**Committee of Experts on the Transport of Dangerous Goods  
and on the Globally Harmonized System of Classification  
and Labelling of Chemicals****Sub-Committee of Experts on the Transport of Dangerous Goods****Forty-fifth session**

**Explosives and related matters:****review of tests in parts I and II of the Manual of Tests and Criteria****Manual of Tests and Criteria****Review of Test Series 8****Transmitted by the Australian Explosives Industry and Safety Group  
Inc. (AEISG)<sup>1</sup>****Introduction**

Figure 18.4.1.1: DEWAR VESSEL WITH CLOSURE

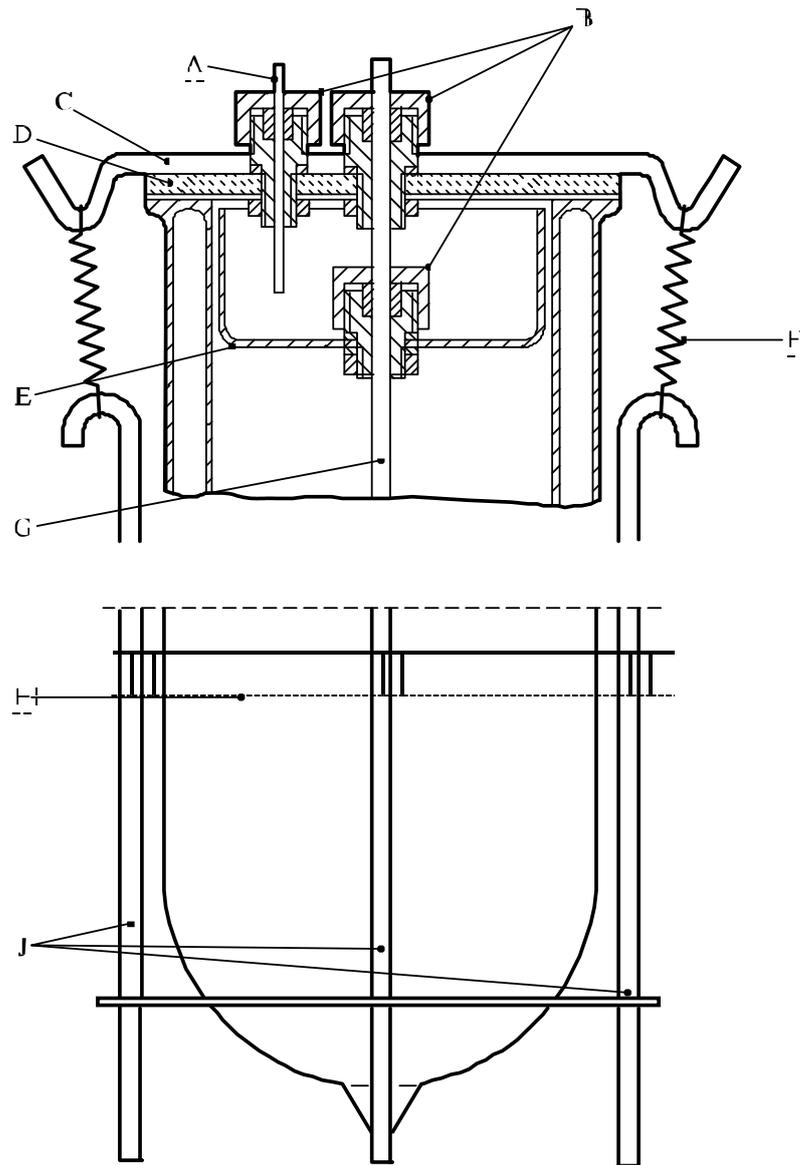
- (ii) The term “Dewar vessel” has been removed throughout, replaced by “insulated test vessel” and the Figure 18.4.1.1, and any reference to it, has been removed. It is considered by various testing agencies that any insulated test vessel with the appropriate heat loss characteristics specified would be satisfactory.

18.4.1.2.4 ~~Dewar~~ Dewar ~~Insulated test~~ Insulated test vessels with a volume of ~~approximately 500 m~~ 500 ~~ml~~ ml with a closure system are used. The closure of the ~~Dewar~~ Dewar ~~test~~ test vessel should be inert. ~~A closure system is illustrated in Figure 18.4.1.1.~~

**Figure 18.5.1.1: ANE GAP TEST**

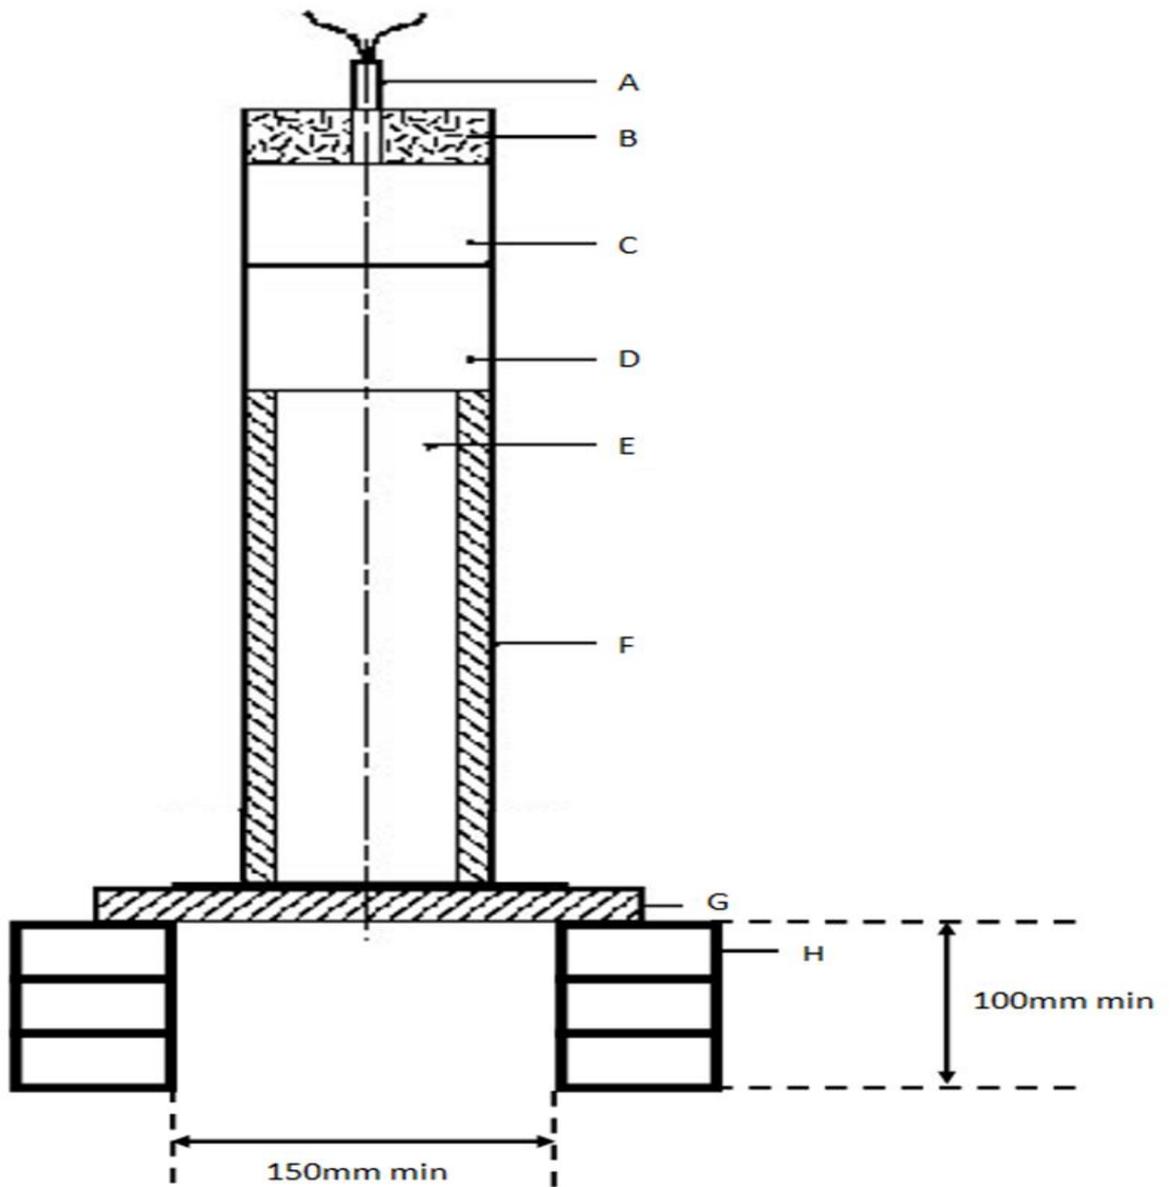
- (vii) The term “approximately” has been included where specifications are considered less important.
  - (viii) Wood blocks, or similar, are added to the apparatus to ensure the whole assembly is mounted at least 100 mm off the ground.

- (x) The reference to conducting the test over water has been removed but replaced with a method to ensure the witness plate is raised at least 100 mm off the ground, with clear space under the plate where the assembly sits.

- (xi) The reference to the gap length in 18.5.1.4 has been removed as unnecessary.
  - (xii) Figure 18.5.1.1 has been updated to reflect the test set up.

Figure 18.5.1.2: ANE Gap Test Calibration Data

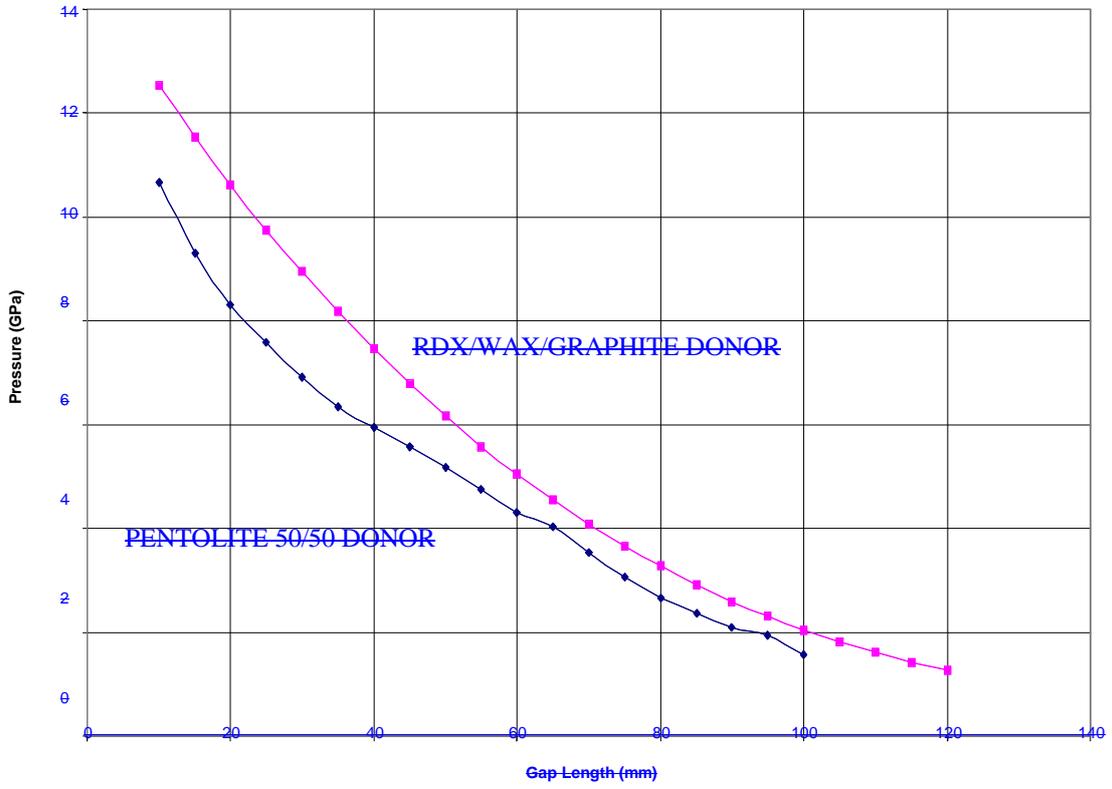
- (v) In 18.5.1.2.1(d) reference to the diameter of the sample is removed.
  - (vi) In 18.5.1.2.1(e) references to the shock pressures, Table 18.5.1.1 and Figure 18.5.1.2 are removed as irrelevant here. The particular Table and Figure referenced are also removed as irrelevant here (these may be considered as useful information for the Appendices).

- (e) Polymethyl methacrylate (PMMA) rod, of 95 mm diameter by 70 mm long; ~~A gap length of 70 mm results in an incident shock pressure at the ANE interface somewhere between 3.5 and 4 GPa, depending on the type of donor used (see Table 18.5.1.1 and Figure 18.5.1.2);~~

**Figure 18.6.1.1: TEST TUBE ASSEMBLY**

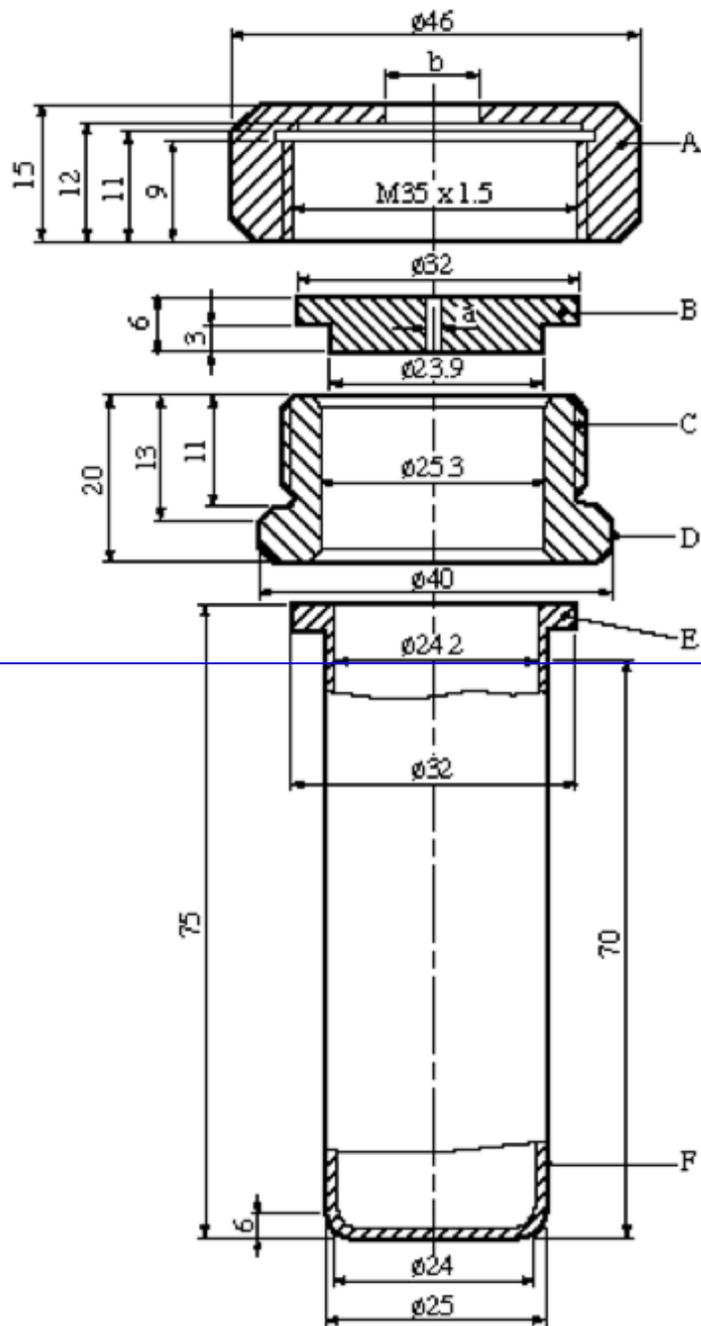
- (ix) Figures have been updated to provide more guidance, clarity.
- (f) 18.7 Series 8 Type (d) Test prescriptions

~~3.1~~ ~~5.0 8.0 12.0 20.0 mm~~. The dimensions of the threaded collar and the nut (closing device) are given in Figure 18.6.1.1.

| <a href="#">(A) Nut (<math>b = 10</math> mm) with flats for size 41 spanner</a> | <a href="#">(B) Orifice plate (<math>a = 1.5</math> or <math>2.0</math> mm)</a> |

**Figure 18.6.1.2: HEATING AND PROTECTIVE DEVICE**

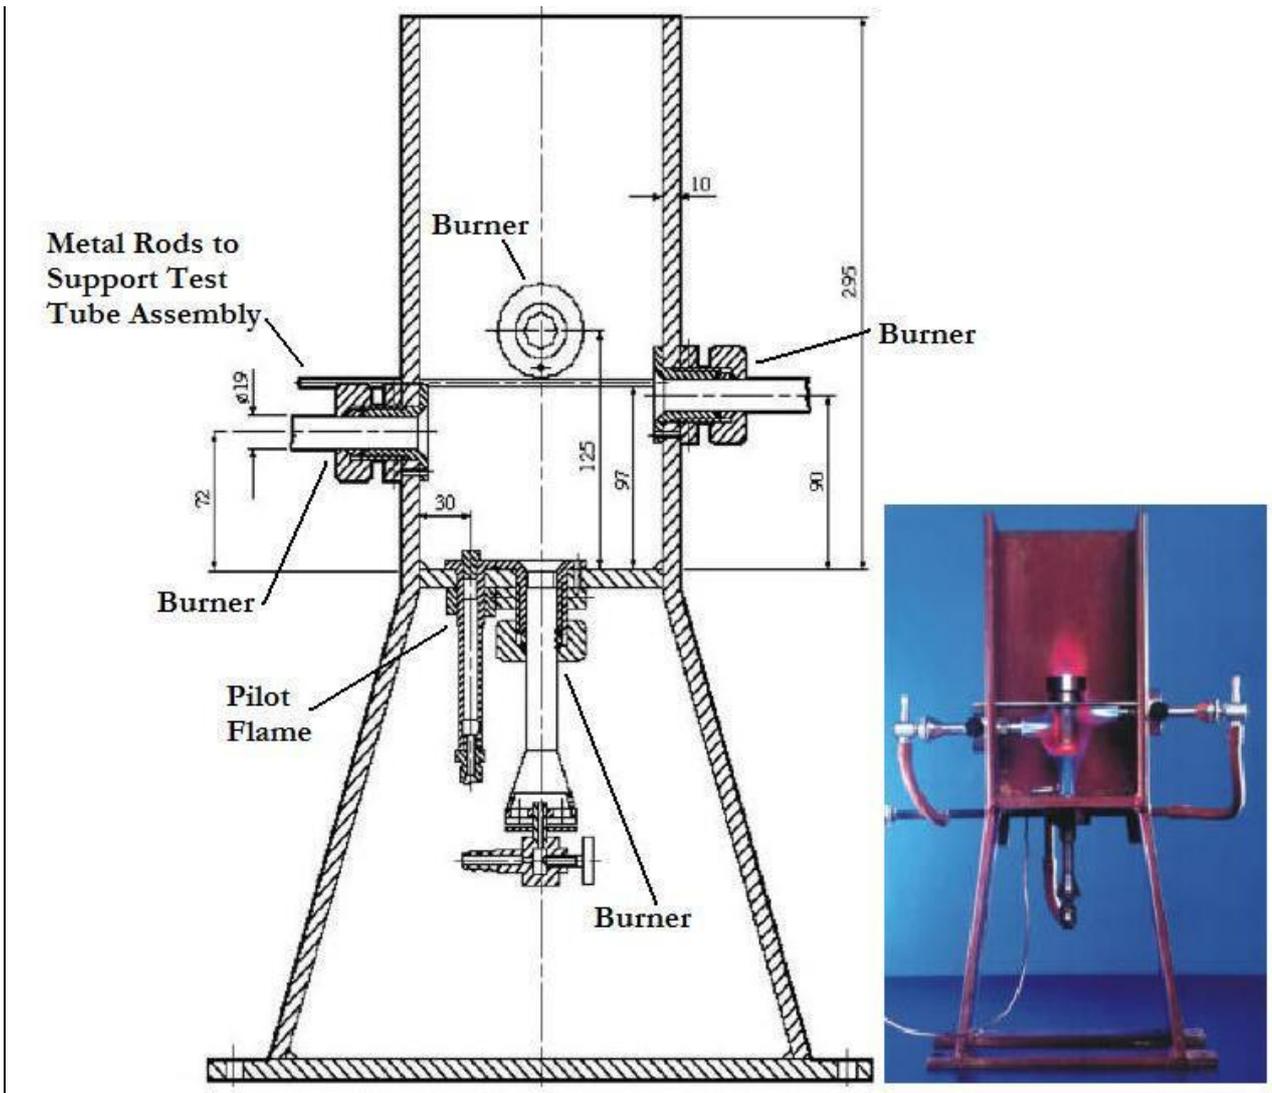
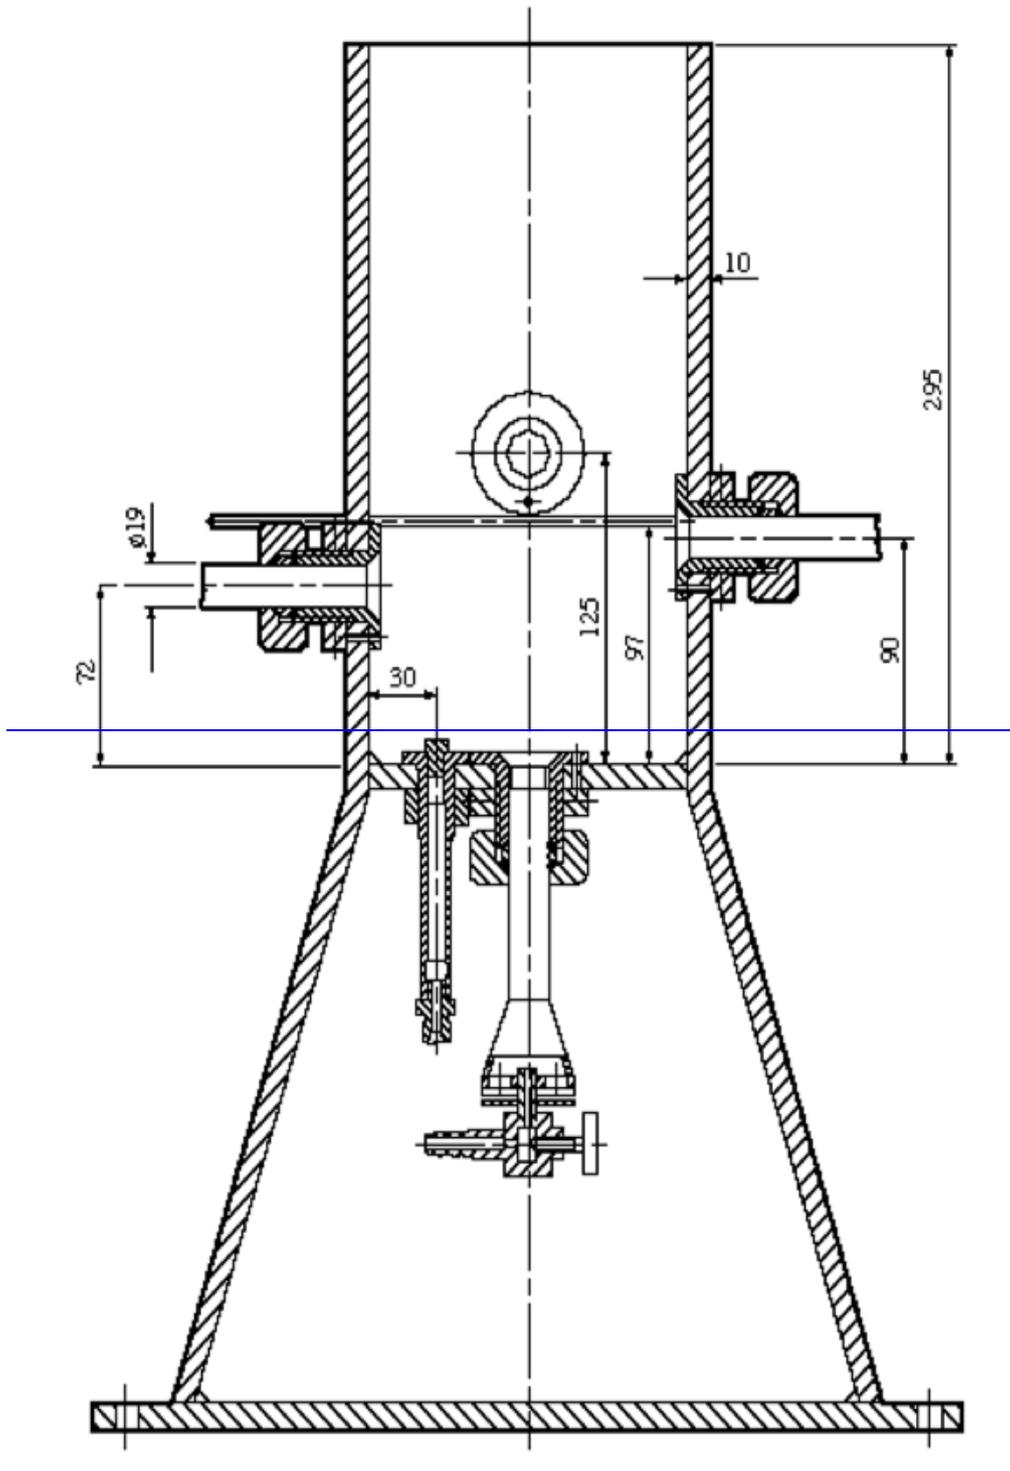
18.6.1.2.3 Because the tube is likely to be destroyed in the test, heating is undertaken in a protective welded box. A suitable arrangement of the construction and dimensions of the box which are given in Figure 18.6.1.2. The tube is suspended between two rods placed through holes drilled in opposite walls of the box. ~~The~~ A suitable arrangement of the burners is given in Figure 18.6.1.2. The burners are lit simultaneously by a pilot flame or an electrical ignition device. *The test apparatus is placed in a protective area.* Measures should be taken to ensure that any draughts does not affect the burner
